Decision Required	
Report Date:	1 November 2011
File No:	RM110394
Report No:	REP11-11-01

Report to: Commissioner Hearing

Subject: Tasman District Council (Nelson Cycle Trails Trust)

Figure 1: Plan of cycle trail from page 17 of the application with position of trail in yellow showing as crossing the small piece of land near the entranceway to Bark Processors Ltd.

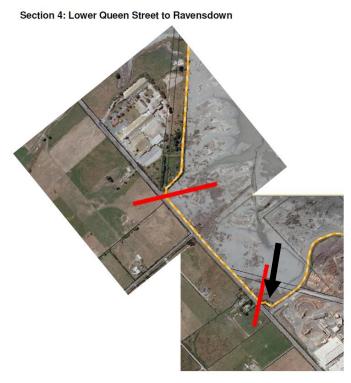
The application showed two different routes at this point in the trail. Route A as shown on pages 17, 21 and Map 2 of Appendix 2 of the application (see Figure 1 for example) shows the cycle trail passing over a small area of raised ground to the northwest of the entranceway and requires a small bridge to be installed. Route B as shown on page 32 of the Ecological Assessment and on page 11 of the Archaeological Assessment bypasses this area of raised ground and hugs the bank near the entranceway to Bark Processors Limited. The applicant has confirmed in their further information response letter dated 5<sup>h</sup> October 2011 that the Route A is their preferred option.

Two submissions have been received regarding the routing of the cycle trail through this area (Forest & Bird and Tils Melis). Both have raised the issue that this piece of land is a high tide refuge for birds which should be protected from disturbance in the absence of any other such land in this area. On page 12 under the heading "Route" of David Melville's report he highlighted the issues regarding the sensitivity of this piece of land. The key points that he makes are:

In my opinion, I agree with the two submitters and Mr Melville that the applicant has not given sufficient reason as to the need for using this route. A precautionary approach should be taken and the requirement to route the track beside the entranceway is considered preferable by the writer. It is noted that there are four potential issues with the alternative route:

- the proposed 150 metre long reclamation at Neiman Creek (unless it can be clearly demonstrated that such access on the landward side of the mean high water spring is not feasible).
- the ford at Borck Creek
- the alignment of the cycle trail at the entrance to Bark Processors Ltd on Lot 1 DP 18146 be in accordance with the route shown on pages 17, 21 and Map 2 of Appendix 2 of the application (unless it can be clearly demonstrated that land owner permission is not obtainable).
